# Strict Priority in P802.1CM

# Goals of this presentation

- › Evaluate the updates needed in 802.1CM due to the recent changes in data flow requirements

# Strict priority example for three CBR flows

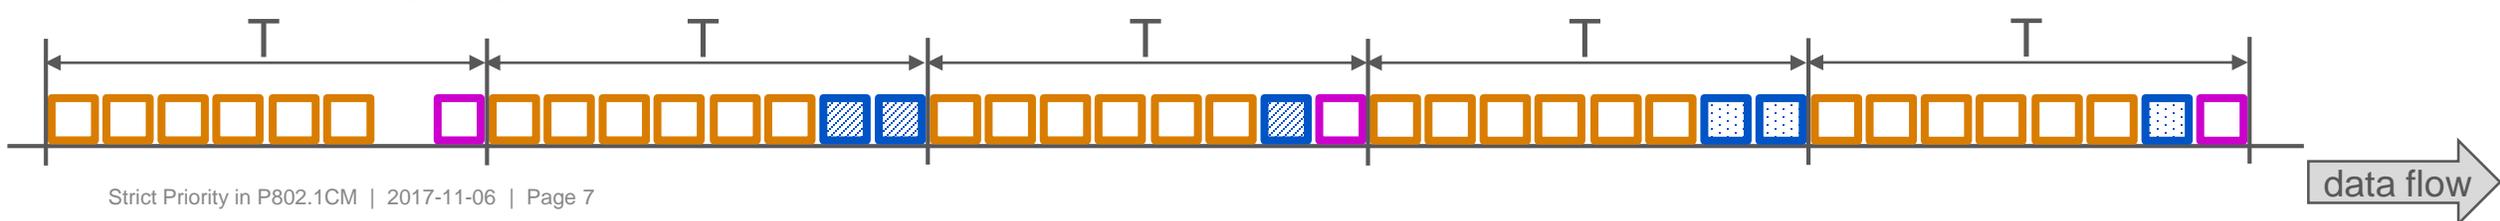
- Add example for the queuing delay of non-high priority traffic class along the one shown in previous slide
